# Comments on SMTC Roundabout Study 2016

Carlo Moneti

March 6, 2017

Figure 4: Reference: SMTC Comstock/Colvin roundabout proposal.

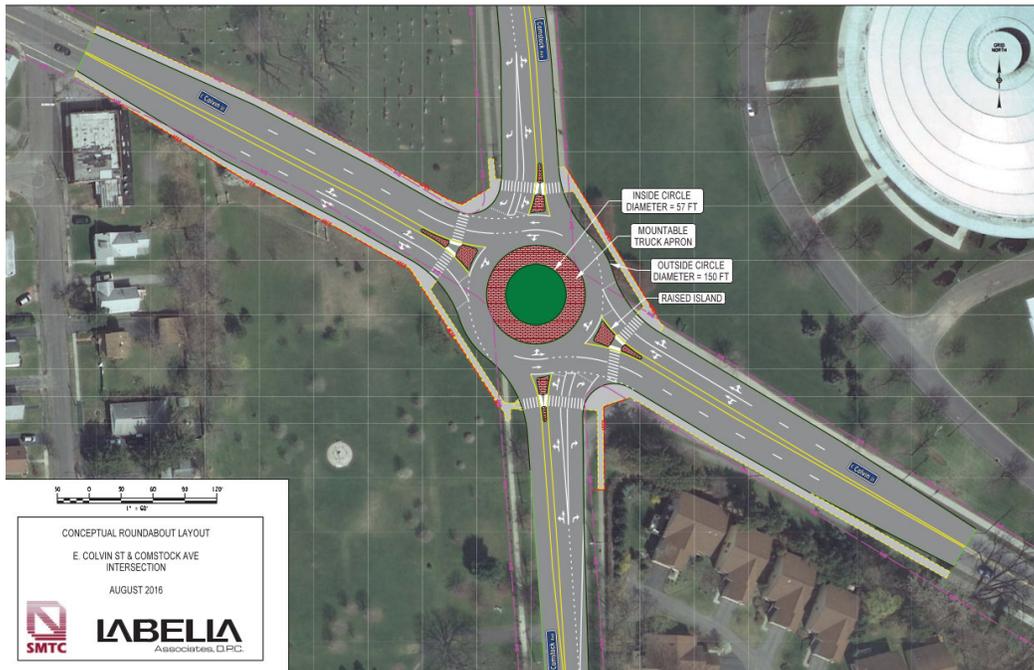
This intersection should benefit nicely from a roundabout solution. The SMTC roundabout concept has two lanes. This is presumably due to the existing 2-lane approaches. However, all four legs of the roundabout are 1-lane each way; they widen at the current intersection to add turning lanes, an optimization strategy for lighted intersections. But this is an artifact of lighted intersections, and is not needed or desirable in a roundabout solution where traffic flow is continuous and capacity is nearly double that of a lighted intersection. Normally, a roundabout connected to roads with one lane each way will have one lane as well.

Understanding that it is just an initial concept, the roundabout has one major design detail of concern: traffic on Comstock Ave (either direction) that turns immediately right on Colvin St negotiates what is (for lack of better terms) virtually an integrated slip lane (vehicle never enters the circle proper); and it faces roundabout exit traffic at 90 degrees, which appears to be a traffic hazard. Separately, in order to increase the smallest turn radii of the unfortunately aligned streets, consider moving the roundabout slightly eastward toward Manley Field House and re-aligning E Colvin St and N Comstock Ave accordingly. A single lane roundabout solution would resolve both issues.

Given that the connecting streets have one lane each way, a 1-lane roundabout seems more appropriate for this location. The benefits of a 1-lane roundabout are several: it can be smaller ( $\leq 120$ ft vs 150ft diameter); it is easier for pedestrians to cross (narrow 2-lane street); it is suitable for cyclist to use; it is less imposing and fits better in a residential/mixed-use setting; and it will be somewhat safer and less expensive to build. I urge SMTC to review its rationale for a 2-lane roundabout and to take a further look at a 1-lane roundabout solution.
